Appl. No.: 09/667,596 Group: 2871

For: THIN FILM TRANSISTOR SUBSTRATE OF

LIQUID CRYSTAL DISPLAY AND METHOD OF

DRAWING CORRECTION AUTHORIZATION REQUEST

FIG.2

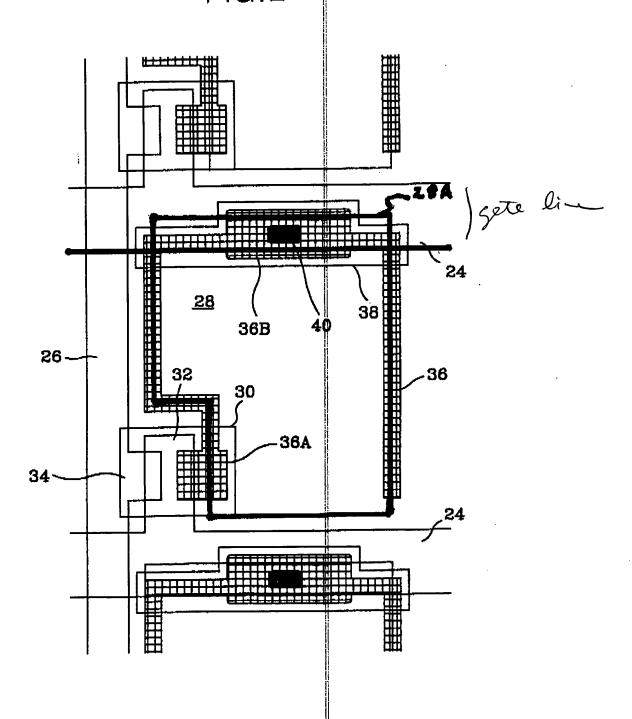
The Examiner objected to the drawings requiring that the recited feature of claim 18, "the pixel electrode overlaps a gate lines less than if the protective layer included a contact hole over a storage electrode part of the metallic pattern" must be shown or canceled from the claim.

Applicant conducted a telephonic interview with the Examiner on March 4, 2002 to discuss the drawings relative to this claimed feature. The Examiner acknowledged that the claimed feature is shown in the drawing, but stated that the feature is not shown with sufficient clarity. Applicant agreed to submit a Drawing Correction Authorization Request (DCAR), proposing changes to the drawings to identify the boundaries of the pixel electrode in a manner such that the extent of overlap/non-overlap of the gate lines is readily apparent. A DCAR is submitted herewith. Applicant has designated the overlapping edge of the pixel electrode as 28A in Figures 2 and 3 and amended to specification accordingly. Withdrawal of the objection is respectfully requested.

Subject to the approval of the Examiner, Figs. 2 and 3 will be amended to as indicated in red on the attached photocopies thereof.

In particular, reference numeral 28A and its associated lead line will be added to Figs. 2 and 3, and the boundaries of the pixel electrode will be clarified such that the extend of overlap/non-overlap of the gate lines is readily apparent.

- 18. (Twice Amended) The liquid crystal device of claim 17, wherein the pixel electrode overlaps a gate line, defining the cell but not connected to the thin film transistor, the overlap of the gate line being less than an overlap in a case wherein [if] the protective layer [included] includes a contact hole over a storage electrode part of the metallic pattern.
